**RE: Notice requiring further information, Application number: PAN-0022125**

Thank you for your Schedule 5 Notice 3 dated 8/8/24 requesting further information regarding the Groundwater Risk Assessment provided in support of an environmental permit to discharge treated sewage effluent to land at Llyn Gwynant Campsite.

**Attachment 3:** Existing Borehole Details

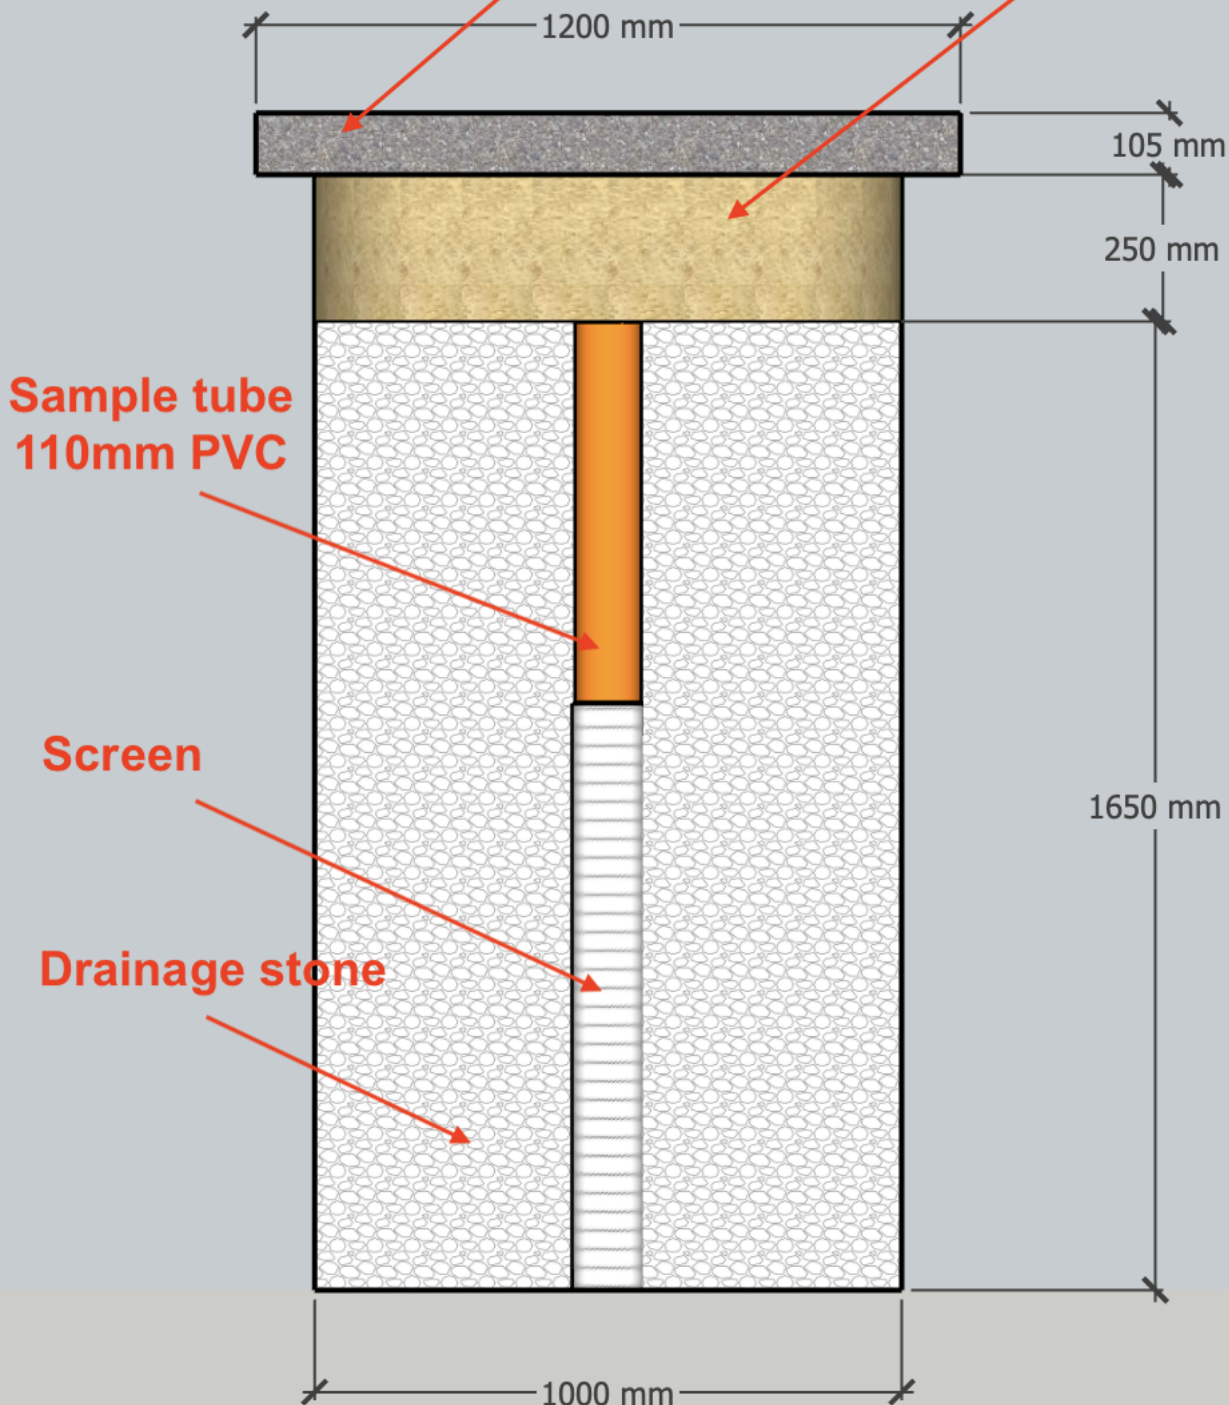
The existing Boreholes (MW2, M3 and MW4) have been used to assess groundwater flow direction and travel time as outlined in our risk assessment report. A sketch drawing of the construction of these existing boreholes is provided as Attachment 3, including proposed modifications to add bentonite and sealed and lockable surface boxes flush with ground level.

**Bentonite seal**

**Stuart Wells CMW8  
190mm BS124 cover**

**Sample tube extends  
up through bentonite  
and slab and is  
sealed to metal cover**

**Slab falls to all  
sides at 3% to  
prevent surface  
water ingress**
